Colours Upgrade Report
Kings Ridge Print Date:08-Feb-13

Model -Windsor (42-03) Elev B

Lot 67 Phase RC

WINDSOR ELEVATION A - 2767 SQ. FT. ELEVATION B - 2712 SQ. FT.

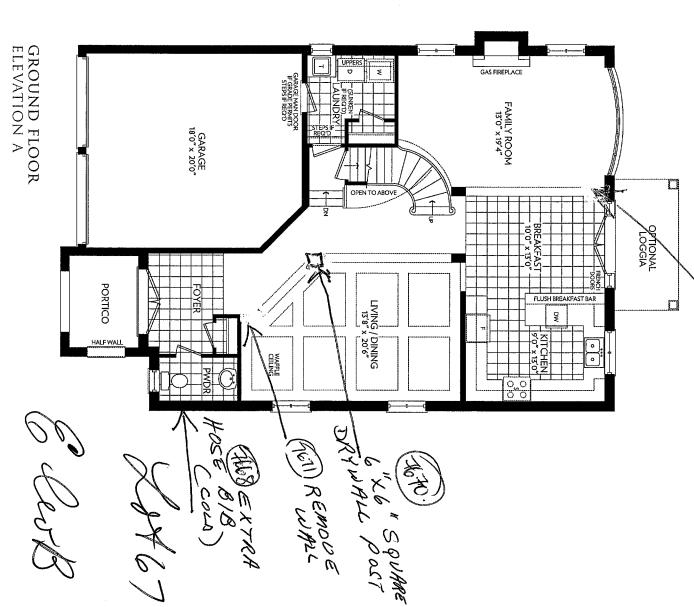
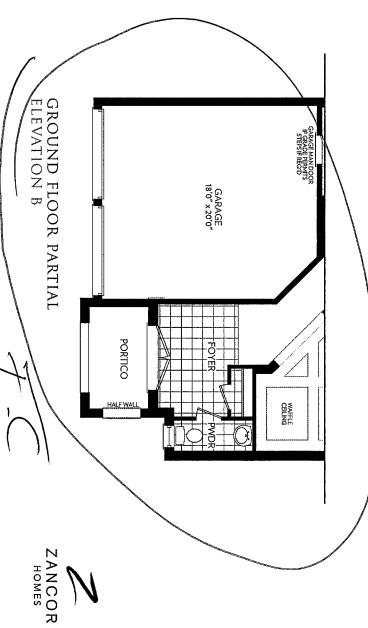
ID	Group	Description	Invoice	Date Ordered	
7662	STRUCTURAL	FRAMING - KITCHEN:  Move fridge wall back 27 inches into dining room / wall beside pantry to remain because there is a structurals post.	1468		
7663	STRUCTURAL	FRAMING - KITCHEN: Shift the window as per QTK revised drawing attached  **Additional cabinetry required for revised layout is NOT INCLUDED in this price. This cost will be paid at decor time.	1468		
7664	STRUCTURAL	BASEMENT WINDOW: One (1) extra basement window - enlarge to 24 inch high by 30 inch wide (window in walk-up larger)	1468		
7665	STRUCTURAL	WALK-UP: Walk-up stairs from basement cement single stair to grade. Double french door into landing / drain. Larger window.	1468		
7667	STRUCTURAL	PLUMBING / FRAMING - MASTER ENSUITE: Remove tub in master ensuite. Rough-in plumbing and drain for future free standing tub and faucet	1468		
7668	STRUCTURAL	PLUMBING - EXTERIOR: Exterior hose bib (cold) to exterior wall by powder room	1468

7669	STRUCTURAL	WINDOWS: Window approximately 42 inch by 48 inch to computer area upstairs (centre)	1468		
7670	STRUCTURAL	DRYWALL - LIVING / DINING: Put in a 6 inch by 6 inch square drywall post instead of wall	1468		
7671	STRUCTURAL	FRAMING - FOYER: Remove wall by foyer	1468		
7672	STRUCTURAL	FRAMING - FAMILY RM: Remove wall in family room at rear between breakfast and family room area	1468		
7673	SCHEDULE E	PLUMBING - KITCHEN: Waterline to fridge *Required as per Frigidaire Gallery appliance package in Schedule E	1468		
7674	SCHEDULE E	ELECTRICAL - KITCHEN: 15 amp plug for future OTR  *Required as per Frigidaire Gallery appliance package in Schedule E	1468		
8293	ADDITIONAL STRUCTURALS	DINING ROOM Extend waffle ceiling into hallway as shown	1578		
8294	SCHEDULE E	BASEMENT WINDOWS: Enlarge four (4) basement windows 24 inches high by 30 inches wide	1468
